**RE: National Construction Code (NCC) 2022 Amendment 2 Volume
One Section J Part J4 Statement of Compliance**

JOB NO.: 240516

SUBJECT PREMISE: Opal Bayview Gardens | Annam Road Bayview, NSW 2104

Attachment B – Building Fabric Requirements Markups

A110 ROOF SCALE: 1:200 0 5.0M 10.0M

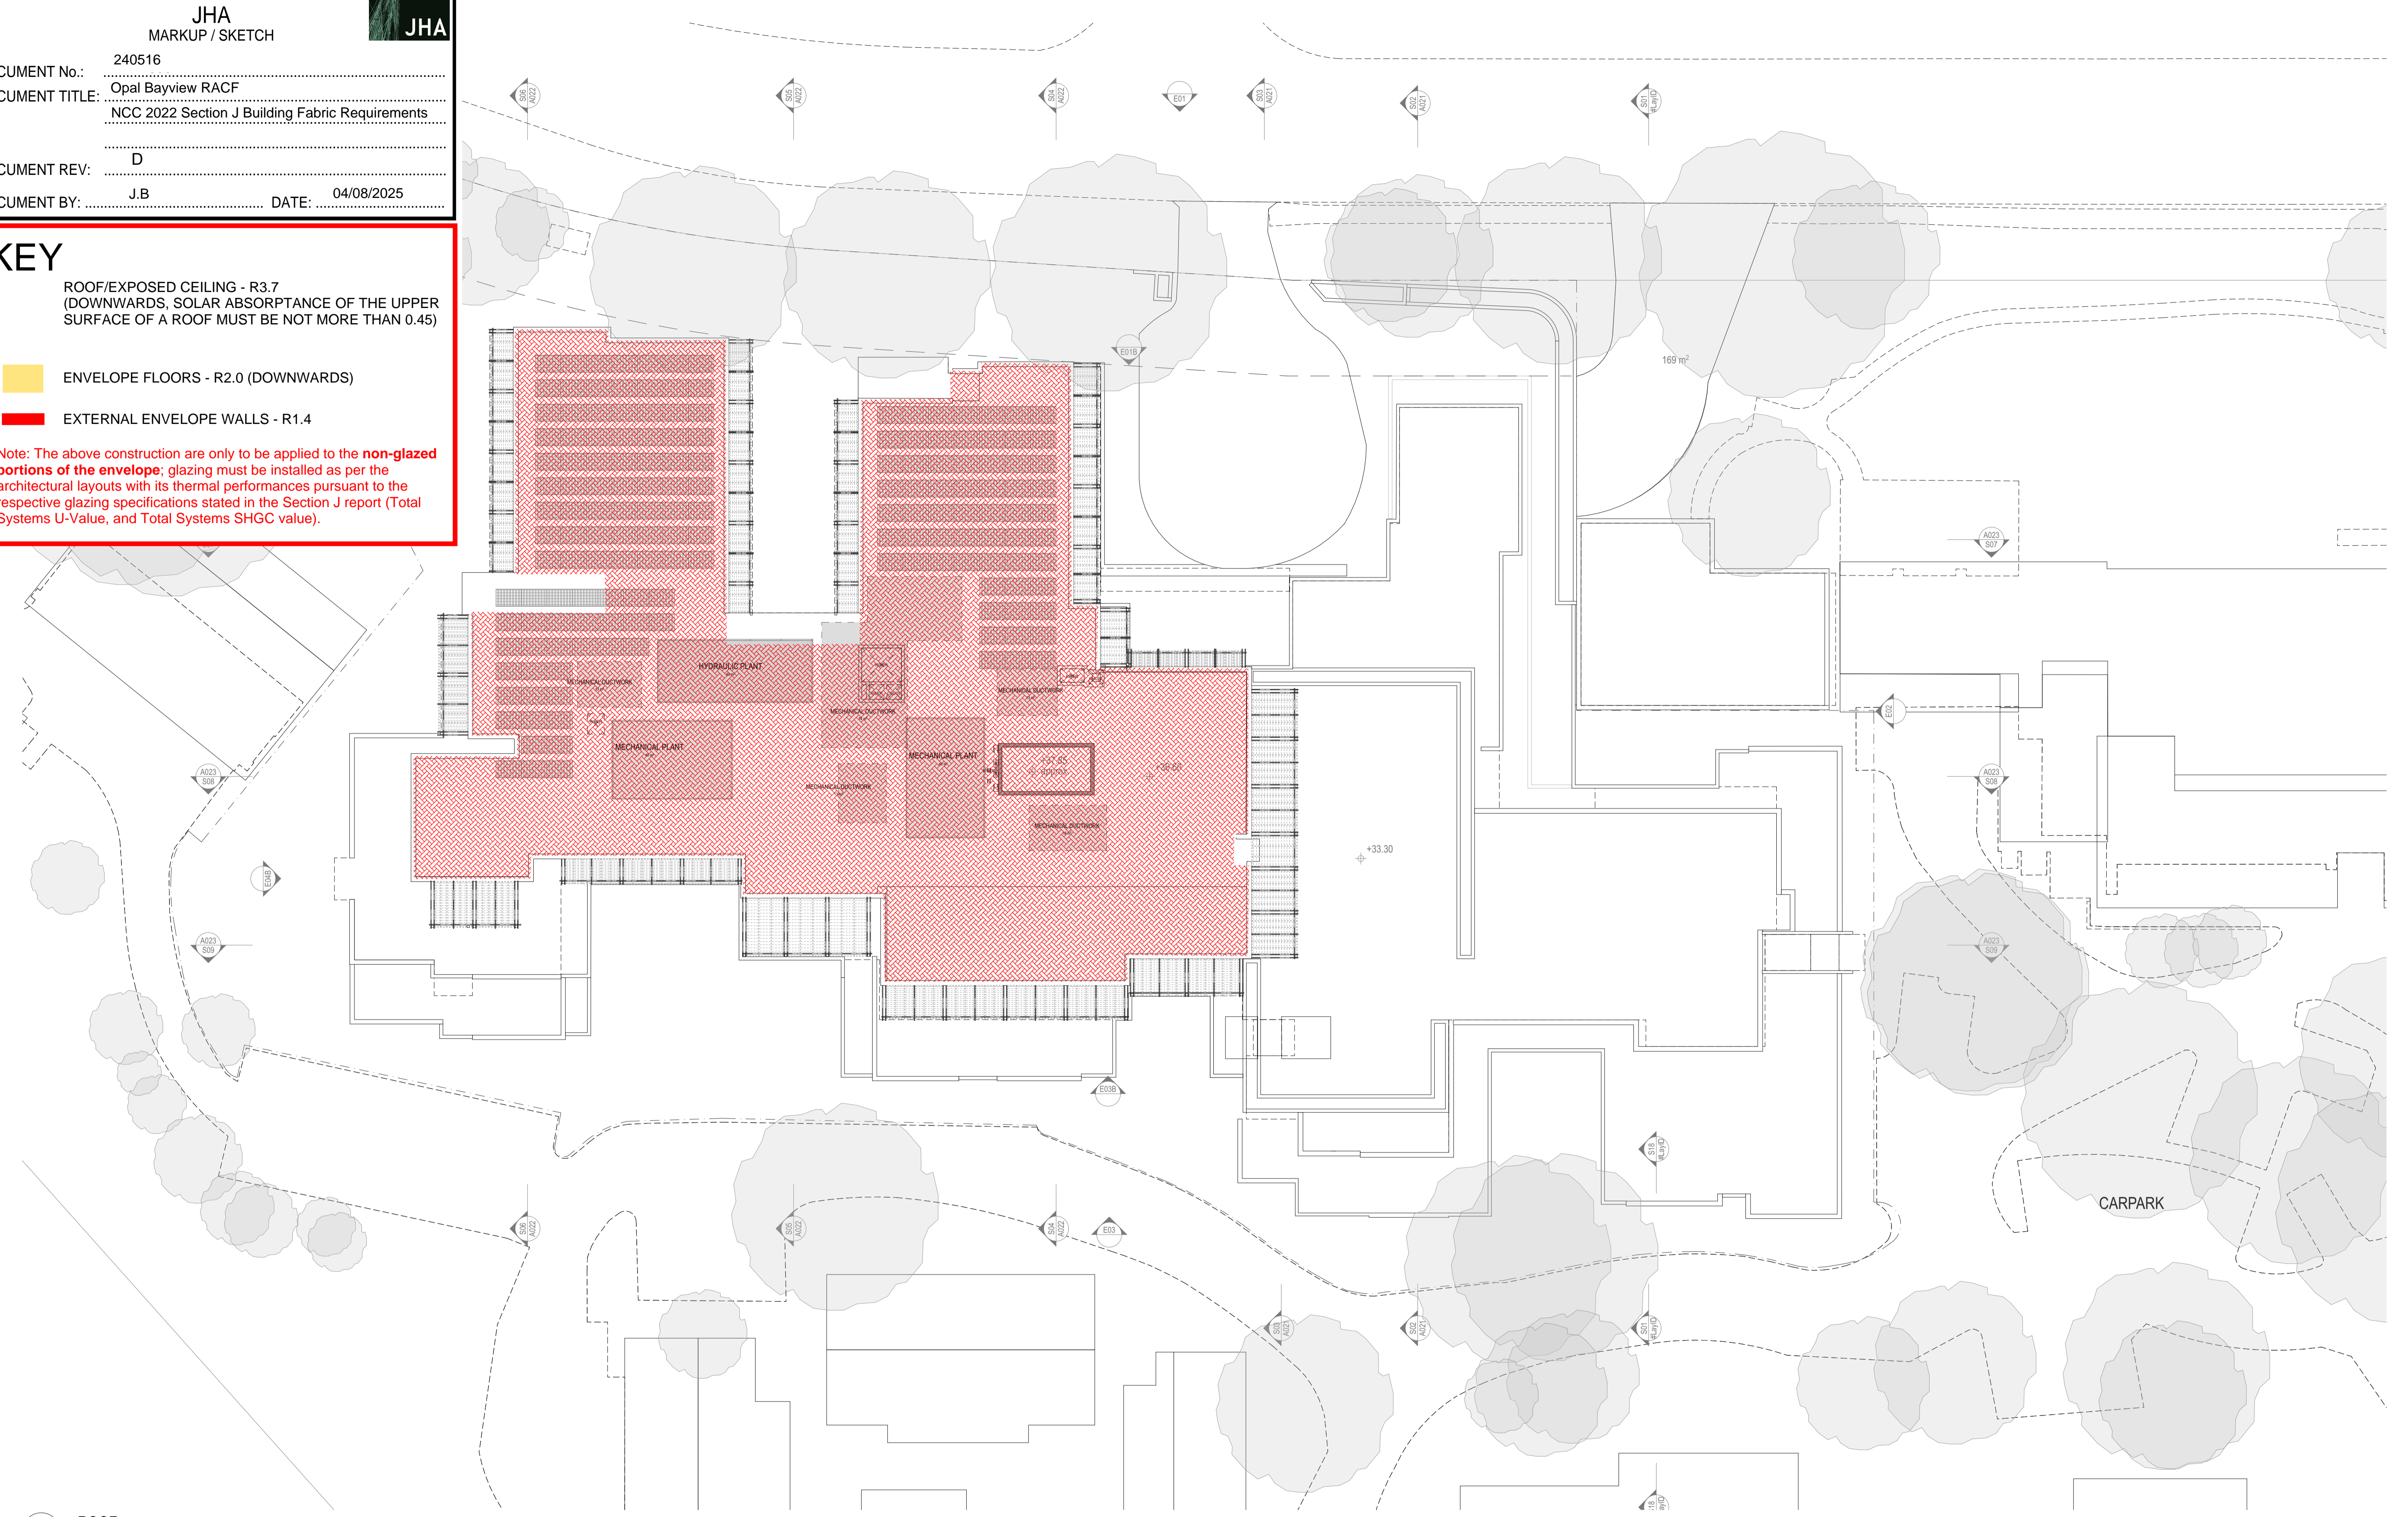
ROOF/EXPOSED CEILING - R3.7
(DOWNWARDS, SOLAR ABSORPTANCE OF THE UPPER SURFACE OF A ROOF MUST BE NOT MORE THAN 0.45)

ENVELOPE FLOORS - R2.0 (DOWNWARDS)

EXTERNAL ENVELOPE WALLS - R1.4

Note: The above construction are only to be applied to the **non-glazed portions of the envelope**; glazing must be installed as per the architectural layouts with its thermal performances pursuant to the respective glazing specifications stated in the Section J report (Total Systems U-Value, and Total Systems SHGC value).
